LSD Gardner Center Food Service

Bid Pack 1, Addendum No. 1

| Project Name: | Gardner Elementary Food Service – Equipment Replacement & Renovations | Date: | February 24, 2026 |

LSD Dwight Rich Food Service Bid Pack 1, Addendum No. 1

SHEET TITLE:
FOOD SERVICE
EQUIPMENT
FLOOR PLAN
SCALE 1/4" = 1'-0"

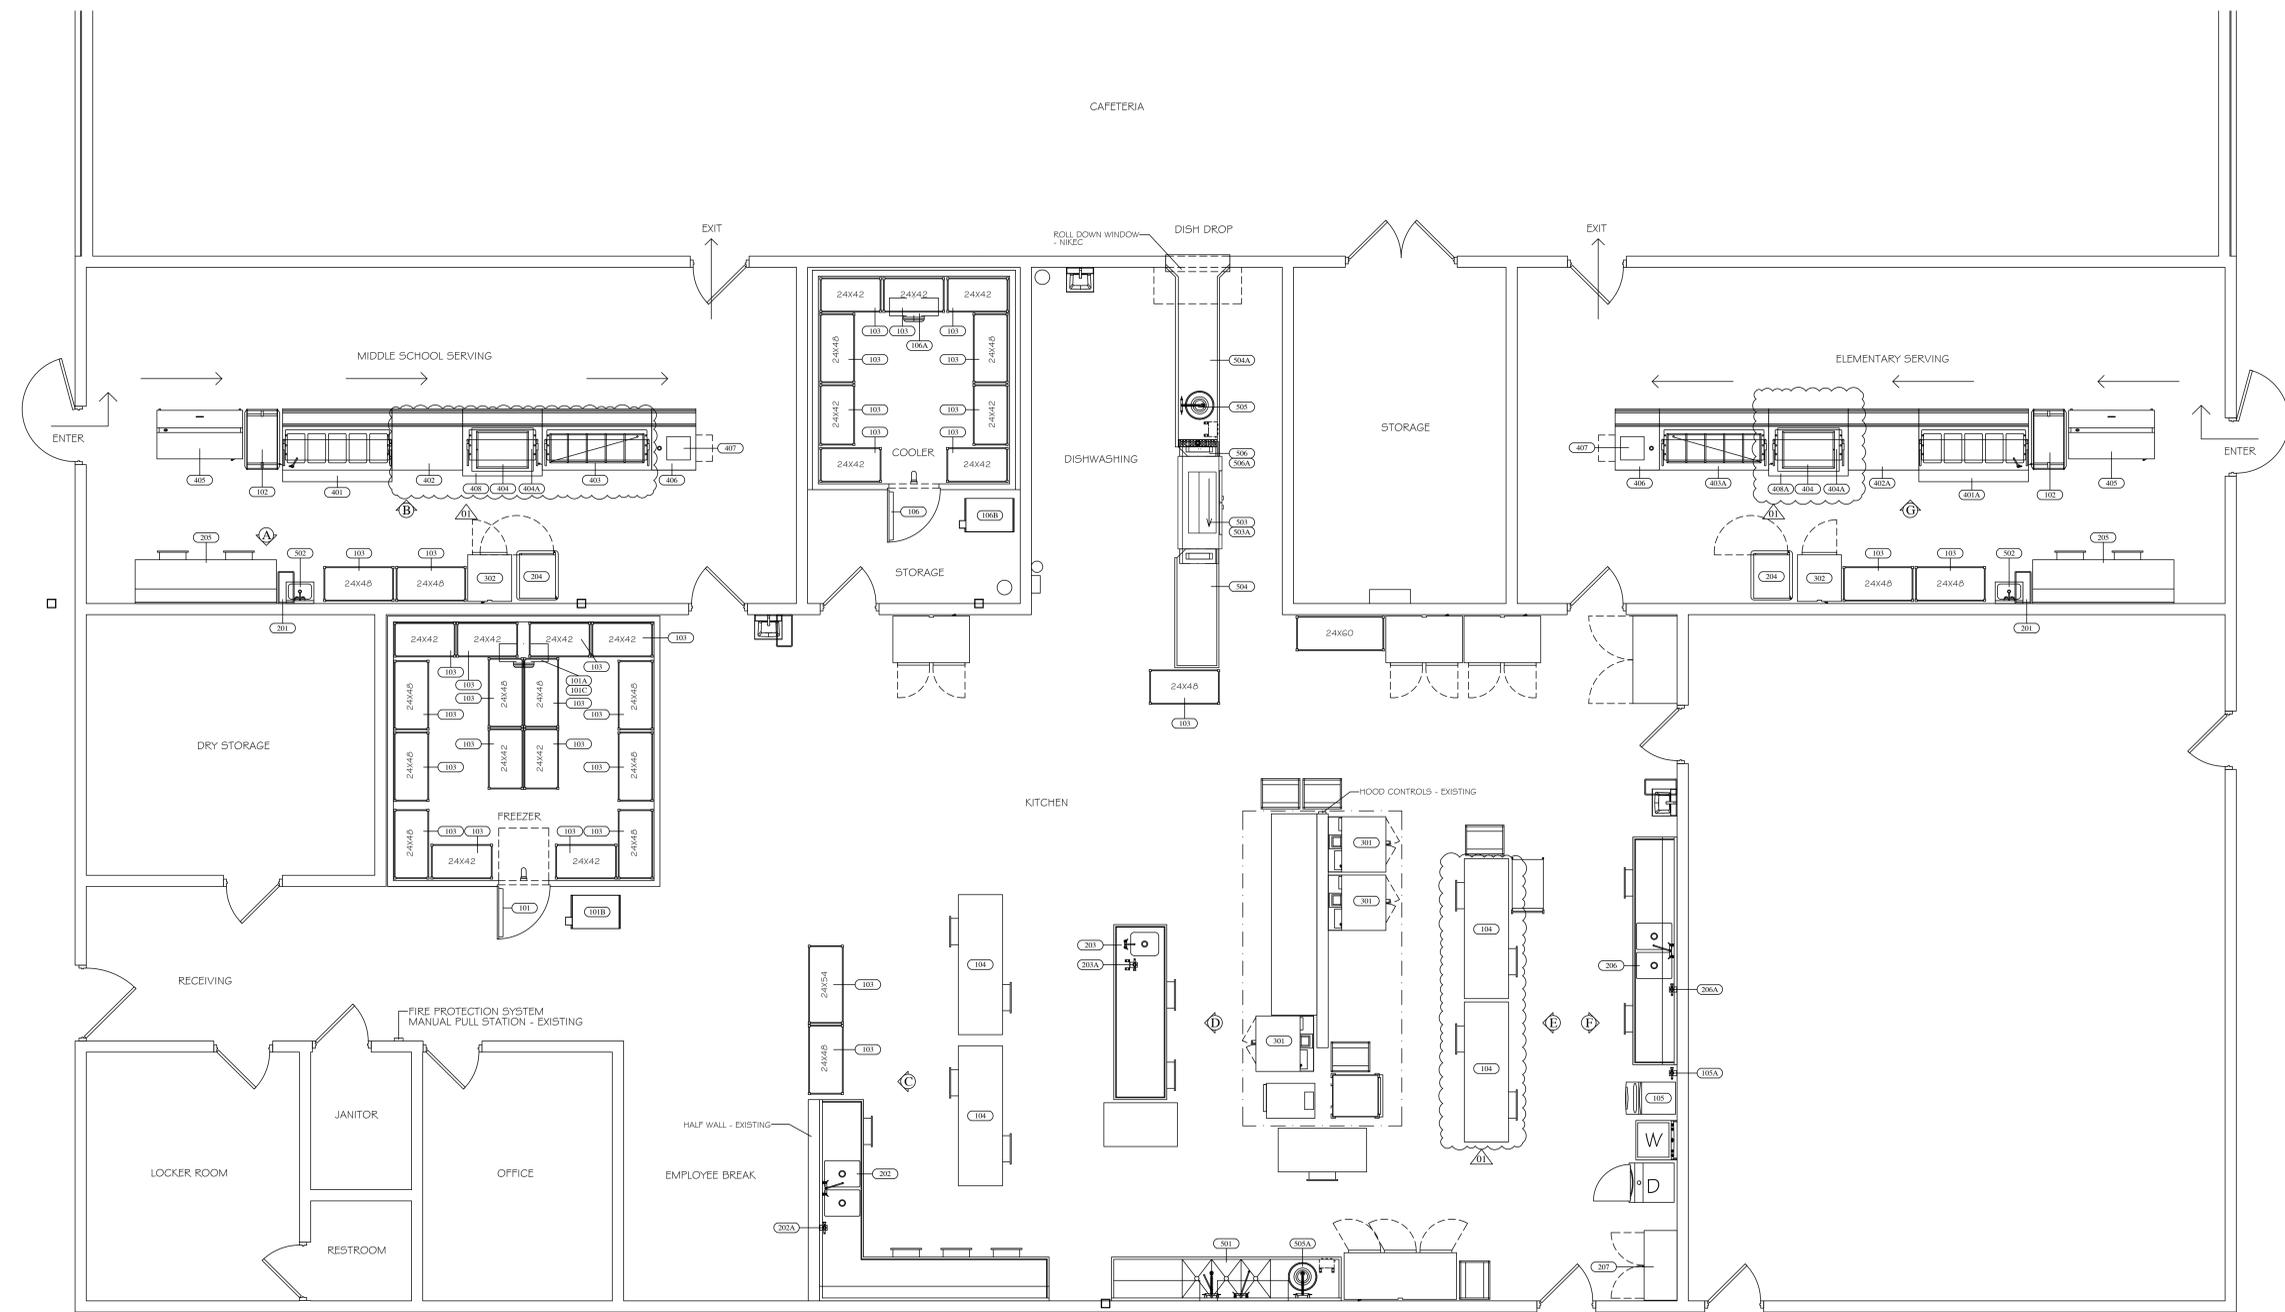
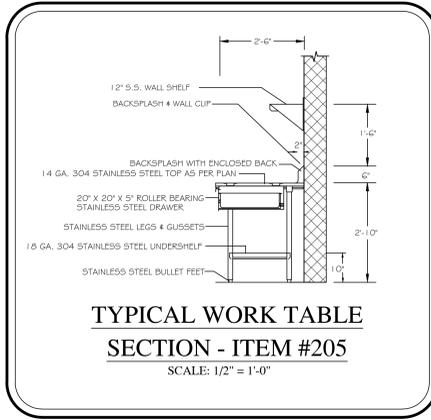
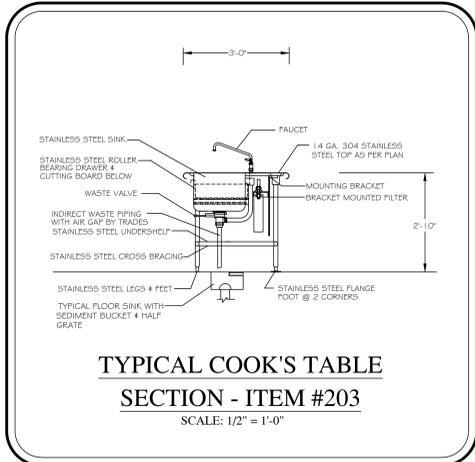
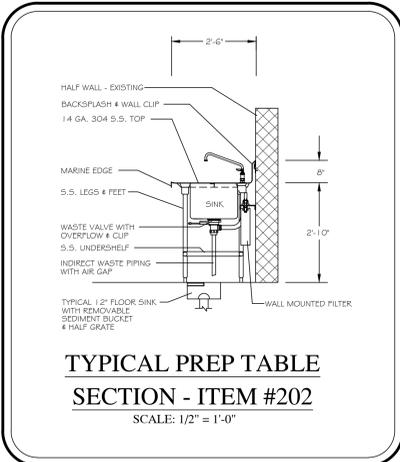
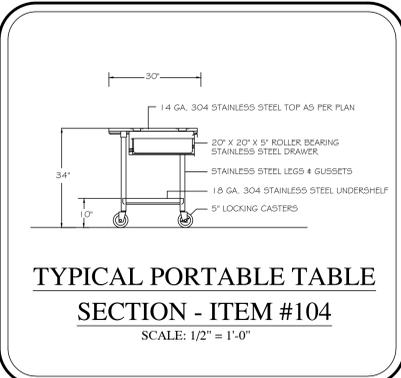
- Sheet FSE-1 is being reissued and FSE-2 is being added to the drawing set.
- Item #104 – Portable Table – Add a Qty. of 2 units with accessories as previously specified.
- Item #402 – Utility Counter – One unit in Middle School serving area to be changed to a counter height of 34”.
- Item #402A – Utility Counter
 - One unit in Middle School serving area to be changed to a counter height of 34”.
 - Both units to be changed in length and width to accommodate the change to Item #404, Frost Top.
- Item #403 – Cold Food Table – One unit in Middle School serving area to be changed to a counter height of 34”.
- Item #404 – Drop-in Frost Top – Both units to be changed Model #N8242-CTP with accessories as previously specified.
- Item #404A – Sneeze Guard
 - Quantity to be changed to 2.
 - Both units to be changed in length and width to accommodate the change to Item #404, Frost Top.

FSE-1

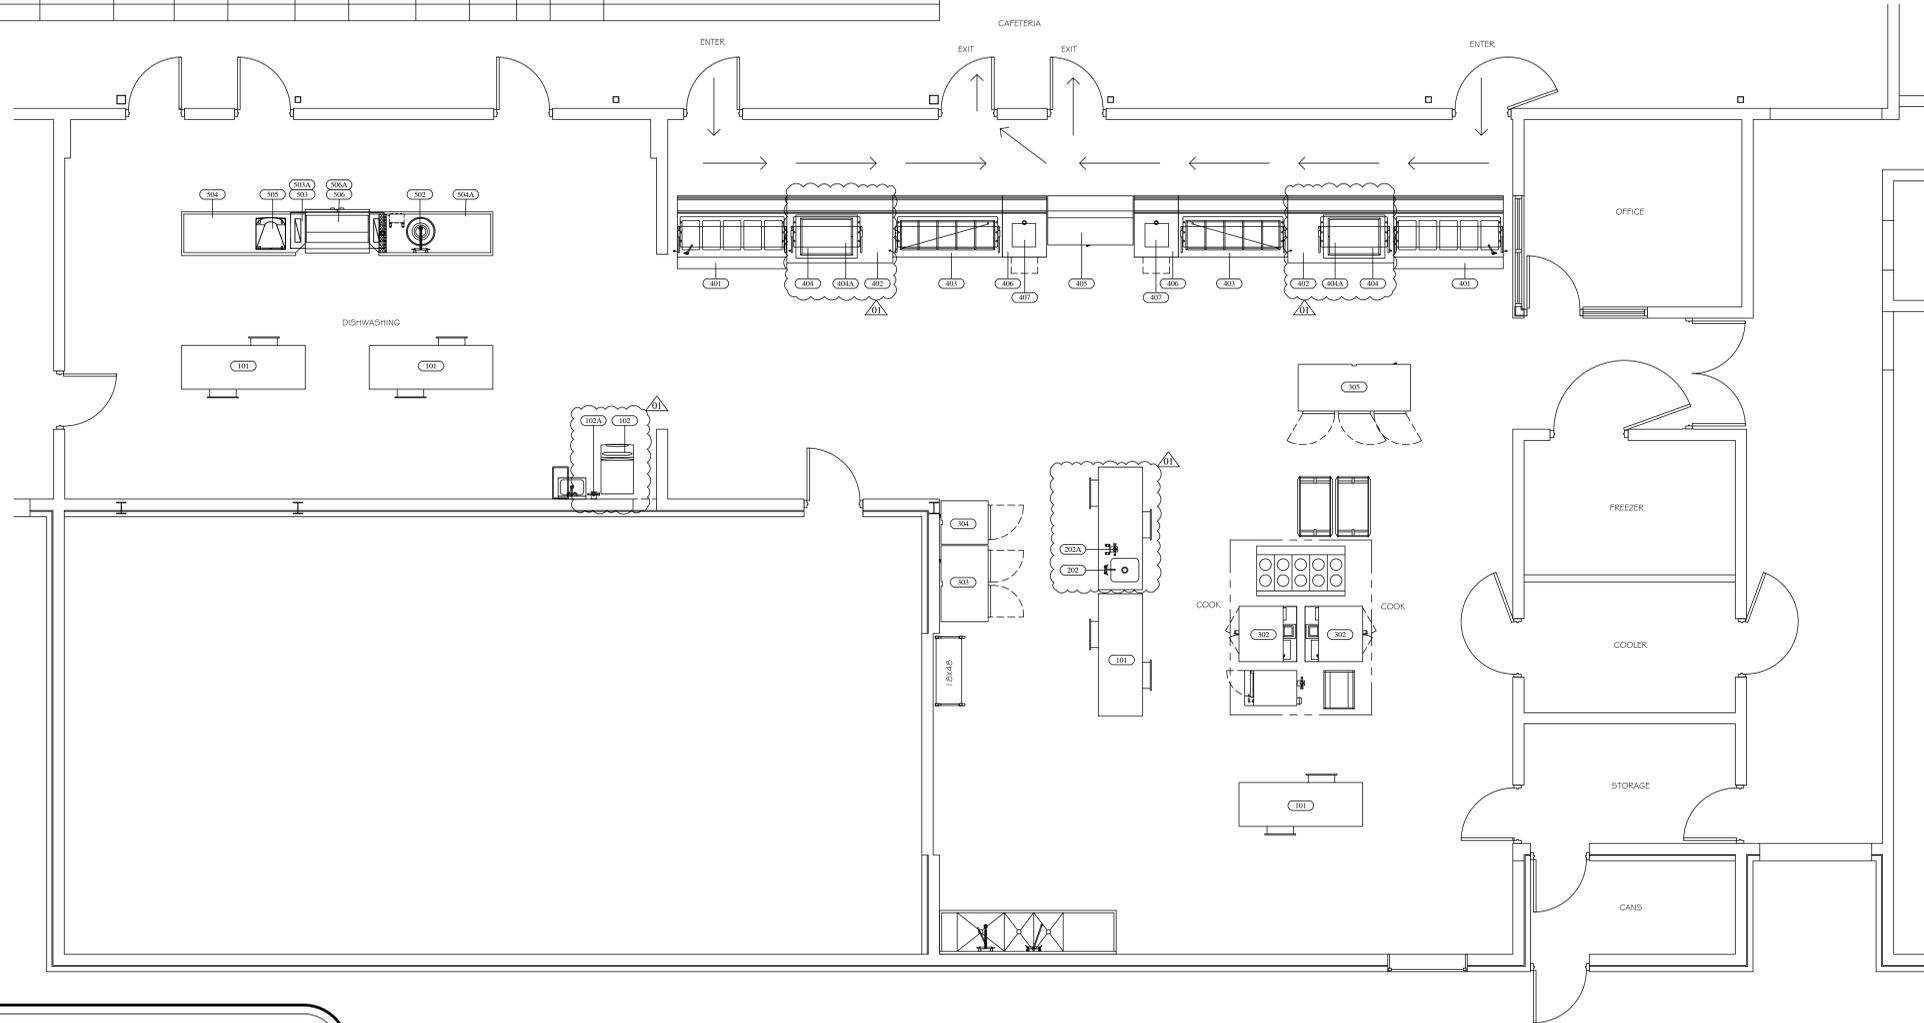
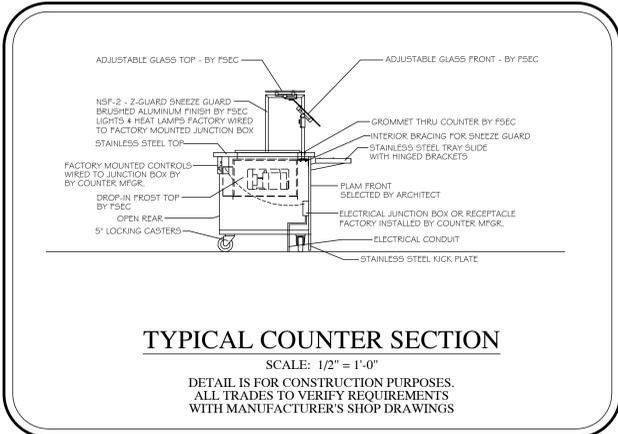
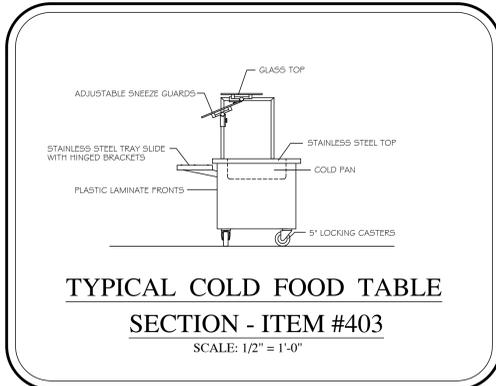
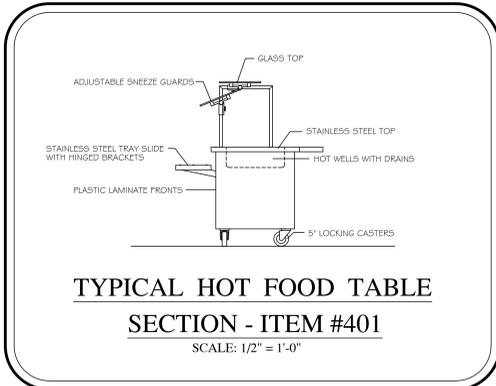
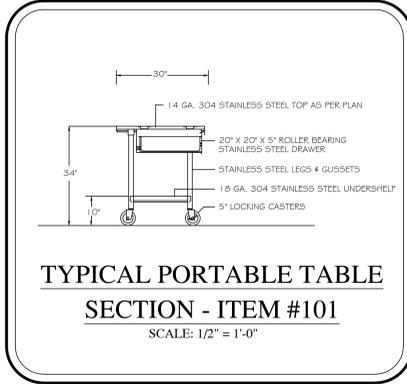
- Sheet FSE-1 is being reissued.
- Added
 - Item #201 – Cook’s Table - Qty. of 1
 - Base Manufacturer: Eagle Group Co. Base Model: YJРАН60SEM
 - Alternate Manufacturer: Approved Manufacturer as listed in Section 2.03 of the General Specifications.

- Minimum specifications:
 - Provide 14 Gauge 304 stainless steel table size and shape as per plan by 34" high.
 - Stainless steel legs, gussets, and a minimum of two adjustable flanged feet.

- Stainless steel sound deadened top with marine edge.
 - 16 Gauge stainless steel under shelf.
 - Two 20" by 20" by 5" deep roller bearing drawer assemblies with stainless-steel or plastic insert and an 18" by 24" white poly cutting board mounted below drawer.

- One 16" by 20" by 14" deep "Coved" corner sinks with T&S Co. B-3990-01 modular waste drain with connected overflows, T&S Co. or Krowne Co. 5F-8DLX12 faucet.

- Everpure Co. or 3M Co. filter model # QC7I Single 4FC with mounting bracket to mount to underside of the tabletop.
 - Item #201A – Cook’s Table Filter – Included in Item #201.

- Item #402A – Utility Counter - Both units to be changed in length and width to accommodate the change to Item #404, Frost Top.
 - Item #404 – Drop-in Frost Top – Both units to be changed Model #N8242-CTP with accessories as previously specified.

- Item #404A – Sneeze Guard - Both units to be changed in length and width to accommodate the change to Item #404, Frost Top.
